Supporting Materials for comment #105

Comment #105

Assumed Software Access speed

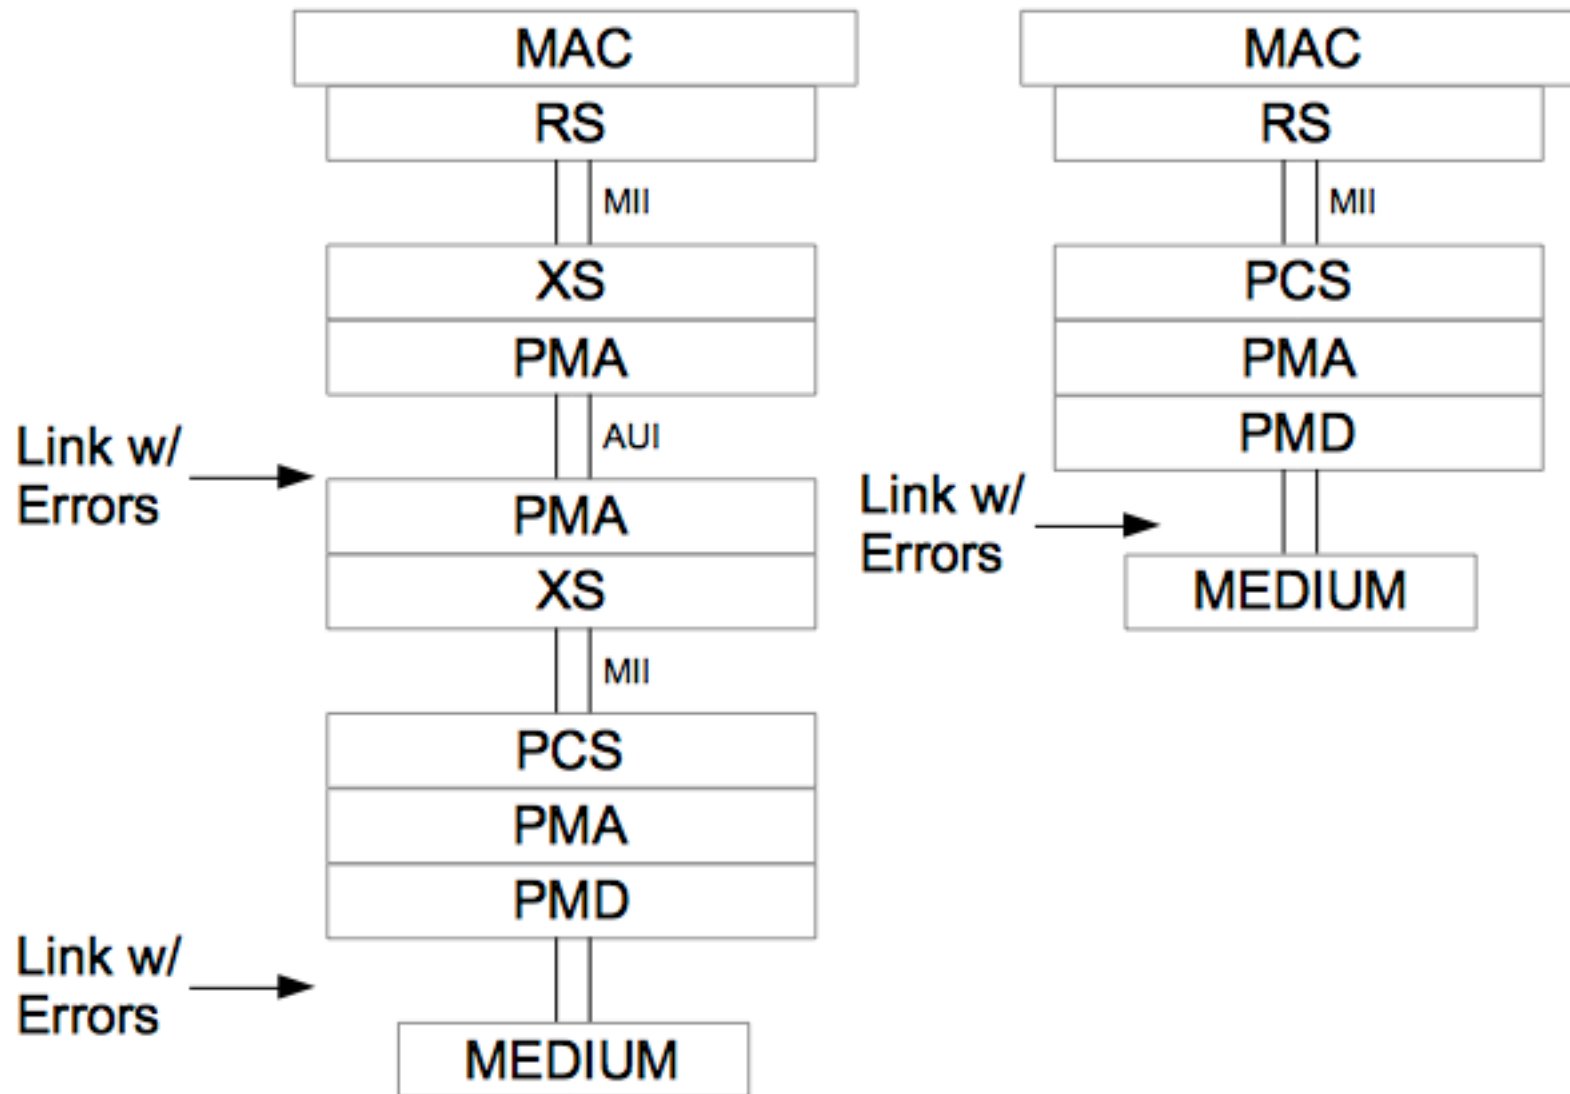
AUI and Medium links can have errors

How I think Degradate should work

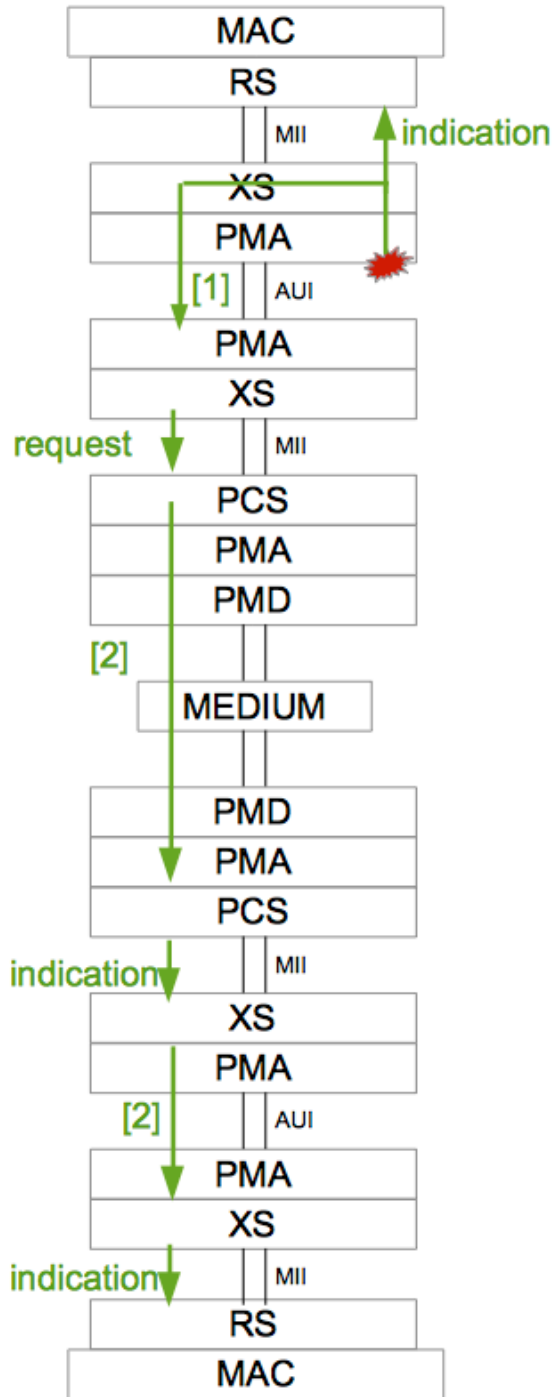
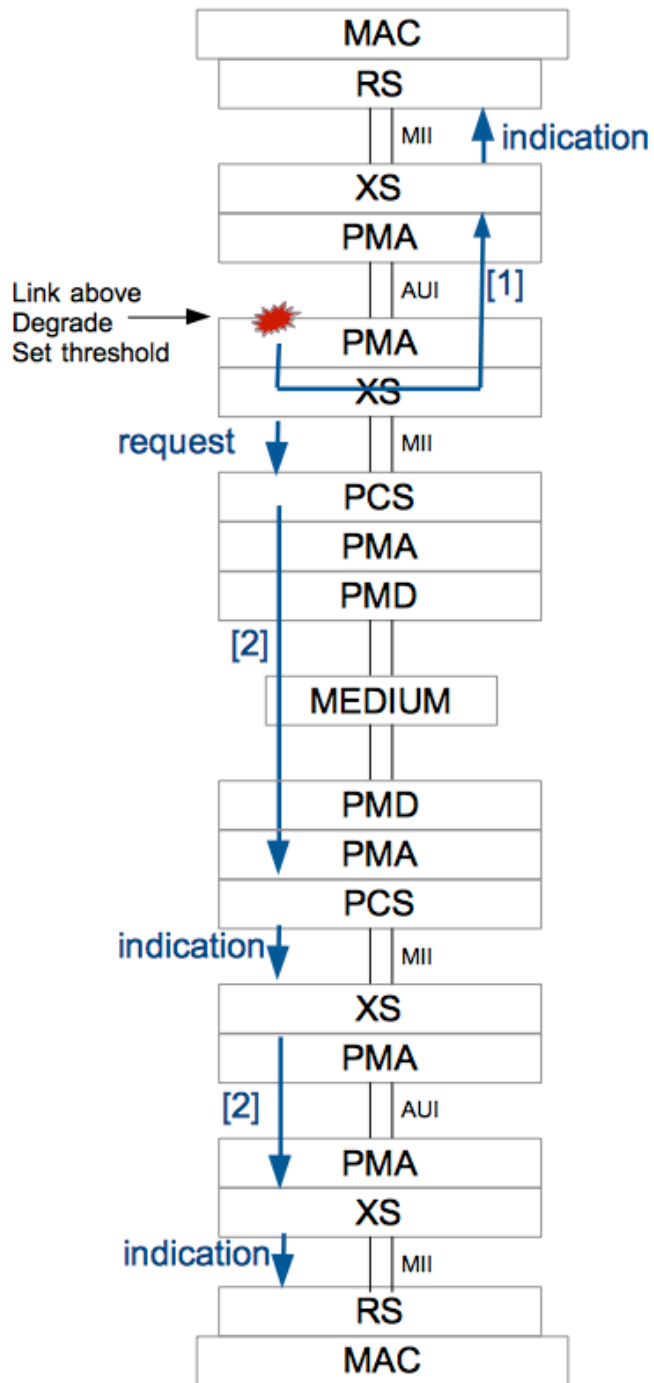
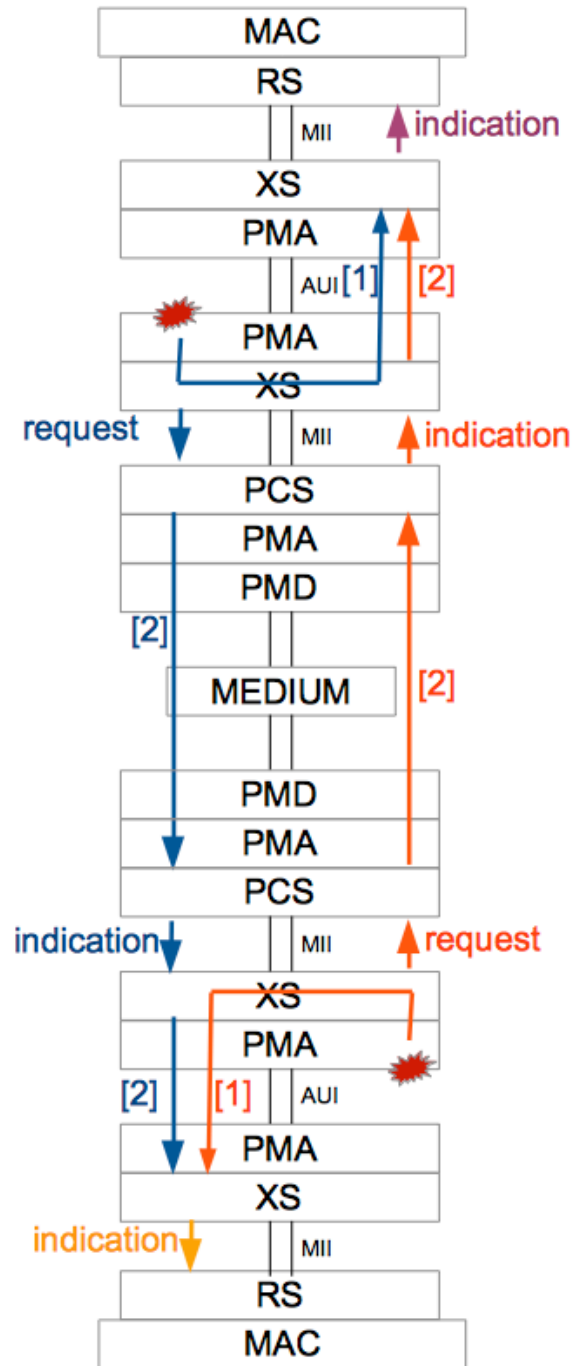
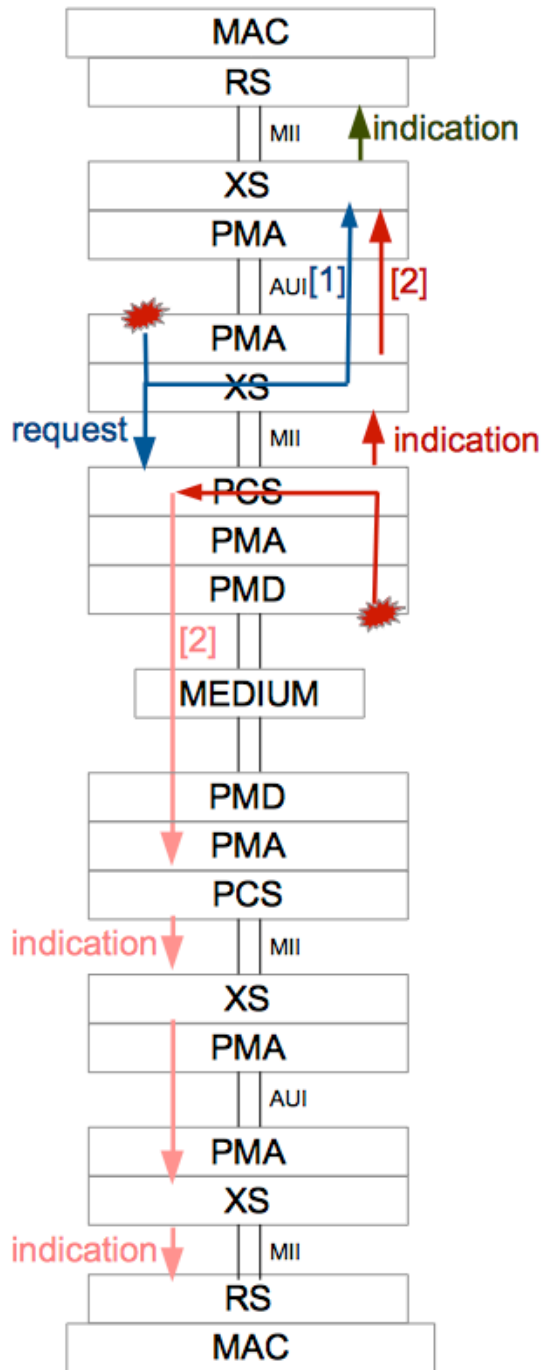
There are 2b of information being passed.

- 1) Degradate condition exist on the link
- 2) Degradate condition exists on local board XS link

Current text uses tx_am_sf<2> to denote link has error and tx_am_sf<1> for local XS.

However current PCS text does not repeat an XS based degrade onto the remote partner. (On next slide Blue line would only loopback and not proceed to PCS)

Since notifications to management are best done at the MAC/RS I believe it's best to repeat the information all the way there. Next set of slides depict how signaling could be done to repeat the degrade notice all the way to the MAC/RS.
